GS-15012

(Replaces GS-15011 and DS-15069)

General Supplemental Specifications for Highway and Bridge Construction

Effective Date
April 20, 2021

Figure 4137.01-01: AASHTO T 350 Test Temperature by County (°C)

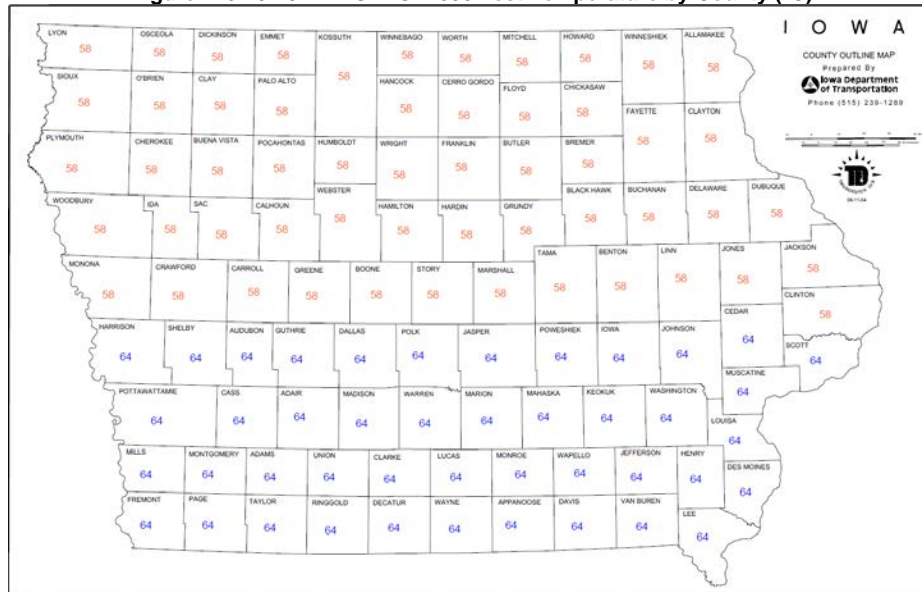
(Delete figure)
